STAFF RECOMMENDATION
2115 Westwood Avenue
January 18, 2017

Application: New construction—outbuilding
District: Hillsboro-West End Neighborhood Conservation Zoning Overlay
Council District: 18
Map and Parcel Number: 10415040200
Applicant: Pam Stoll
Project Lead: Melissa Sajid, melissa.sajid@nashville.gov

Description of Project: The request is to construct an addition to an existing carport.

Figure 1: 2115 Westwood Avenue

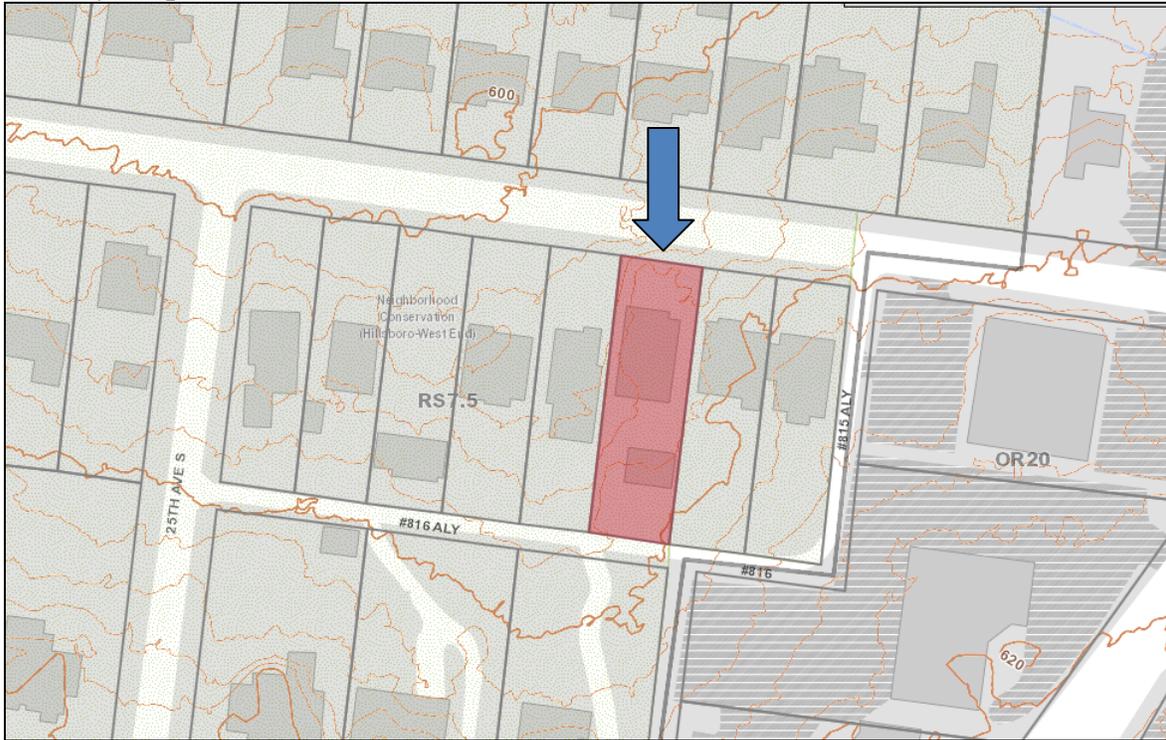
Background: The house located at 2115 Westwood Avenue is a c. 1925 Tudor Revival style building that contributes to the historic character of the Hillsboro-West End Neighborhood Conservation Zoning Overlay (Figure 1). In August 2016, MHZC staff issued an administrative permit to construct an addition to an existing carport that would increase the total footprint to six hundred and ninety-six square foot (696 sq. ft.). The previously permitted addition was not constructed. The outbuilding is a detached garage and does not include a dwelling unit.

ROOF PLAN
SCALE: 1/4" = 1'-0"

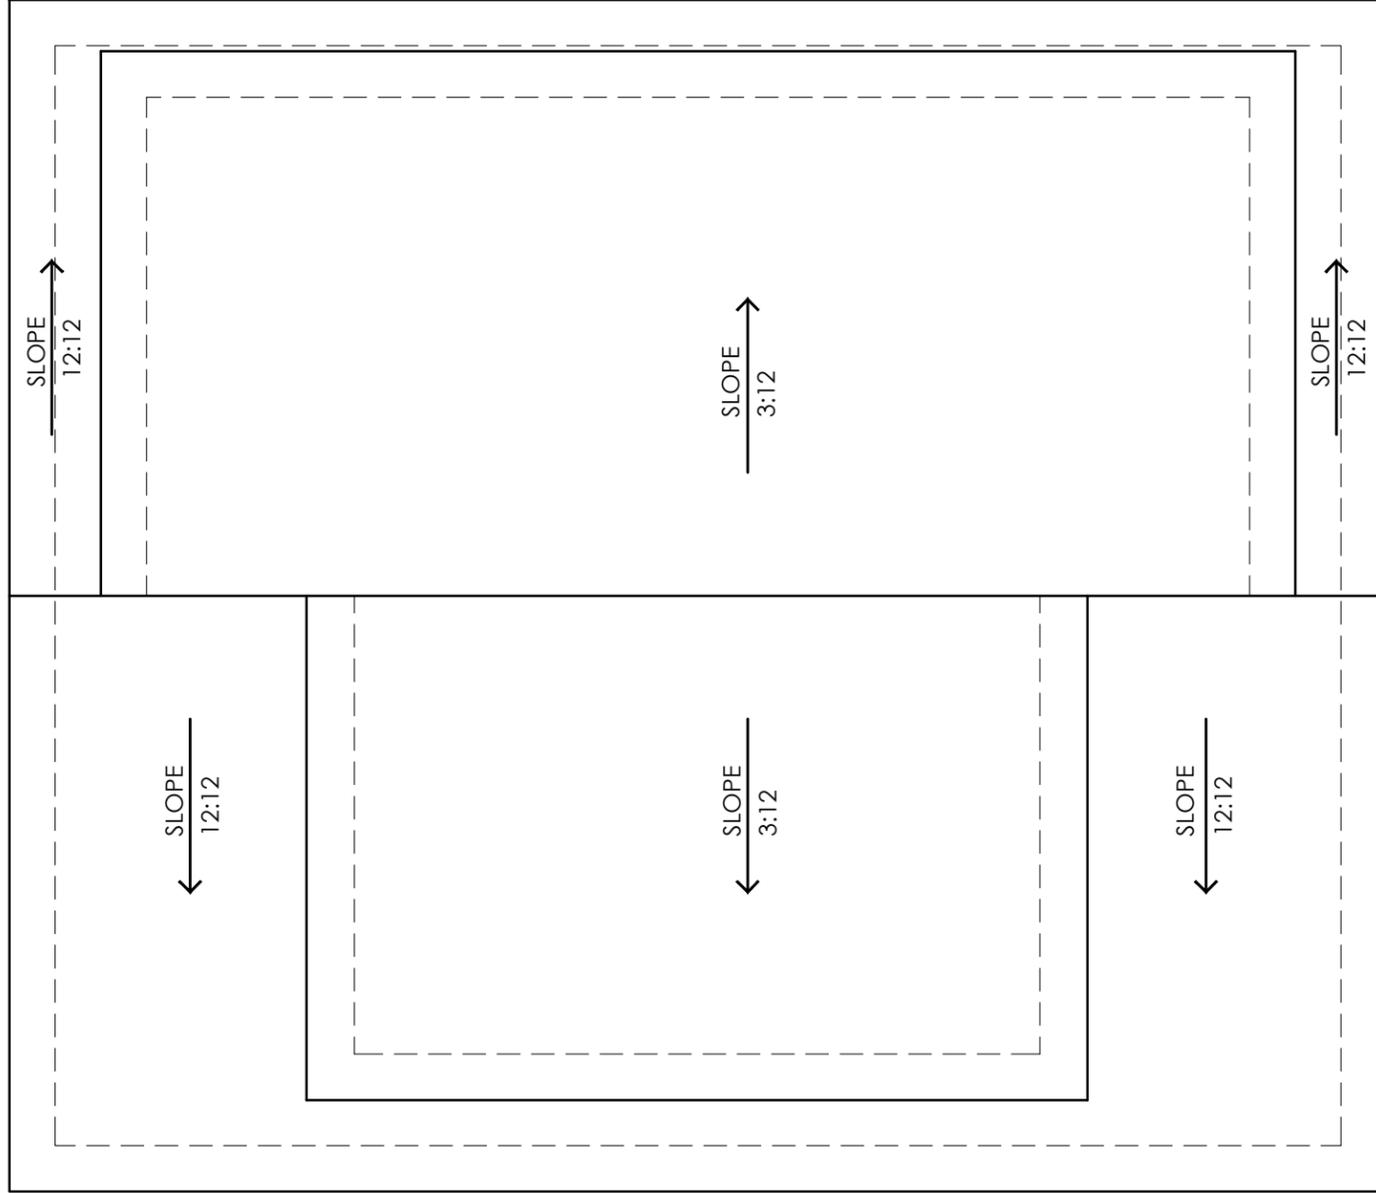
Proposed Element	Proposed Form	Typical of district?
Primary form	Gable	Yes
Primary roof slope	12/12	Yes
Dormer form	Shed	Yes
Dormer slope	3/12	Yes

Since the form and slopes are similar to historic outbuildings and do not contrast greatly with historic house, staff finds that the project meets Section II.B.h.1. of the design guidelines.

FRONT ELEVATION - NORTH
 SCALE: 1/4" = 1'-0"

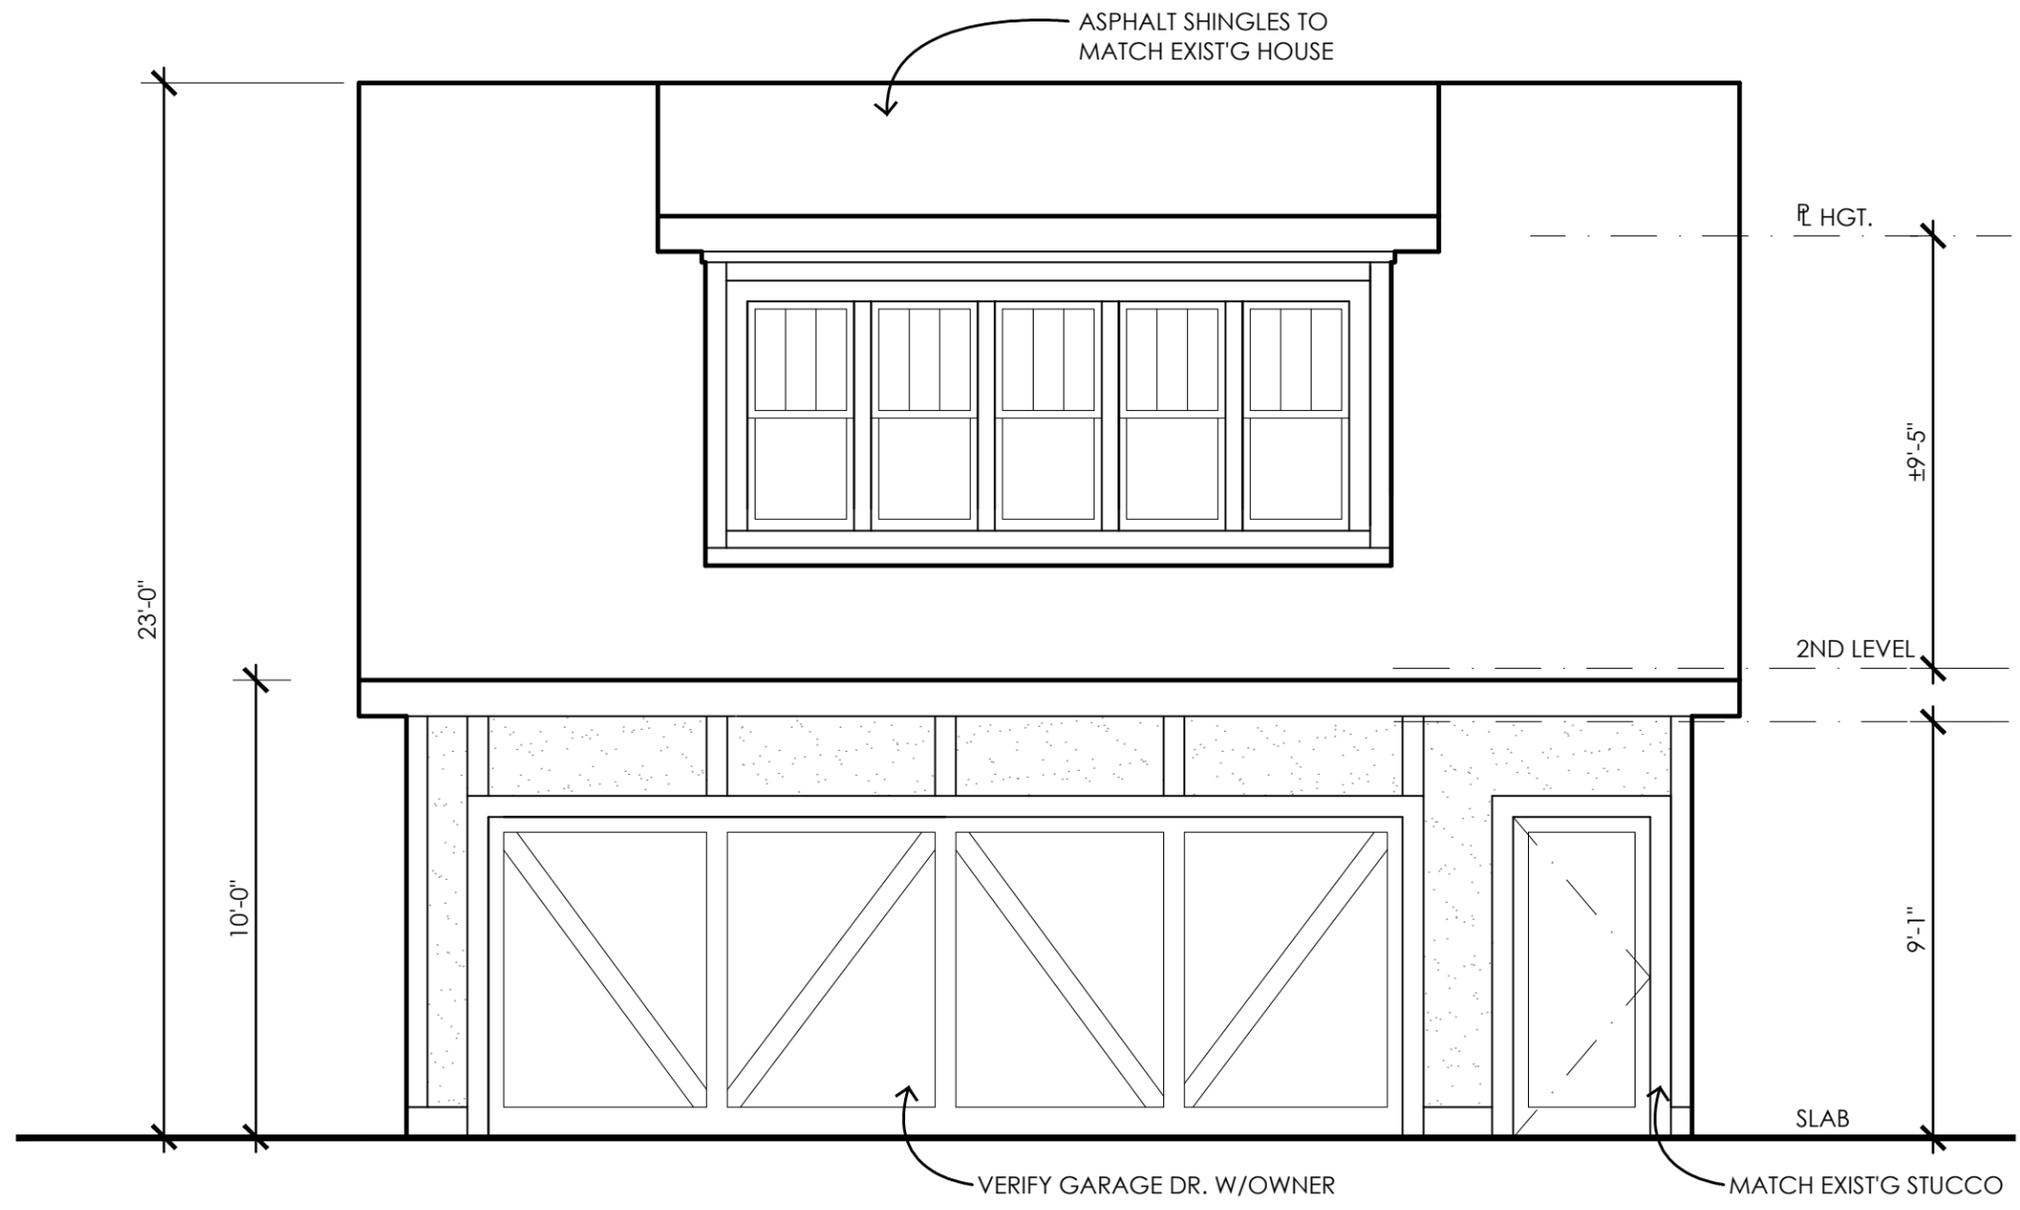
The proposed outbuilding addition is one and one-half story and does not exceed the maximum ridge height, average eave height, and footprint per the design guidelines. The plan includes dormers on the front and rear of the outbuilding. Both dormers sit back from the wall below by two feet (2') as required by the design guidelines. The front dormer does not exceed more than fifty percent (50%) of the roof plan as required; however, the proposed rear dormer does exceed fifty percent (50%). Since the rear dormer will not be visible from the street and the proposed outbuilding does not include a dwelling unit, staff recommends approval of the proposed rear dormer.

The outbuilding is situated behind the historic house in the same location as the existing carport and will be accessed from the existing driveway on Westwood Avenue. While the vehicular doors will be oriented to the street, the majority of the outbuilding is located behind the historic house and will not likely be visible from the street. As a result, staff finds the proposed single two-bay garage door appropriate in this case and finds that the project meets Section II.B.h.1 of the design guidelines.
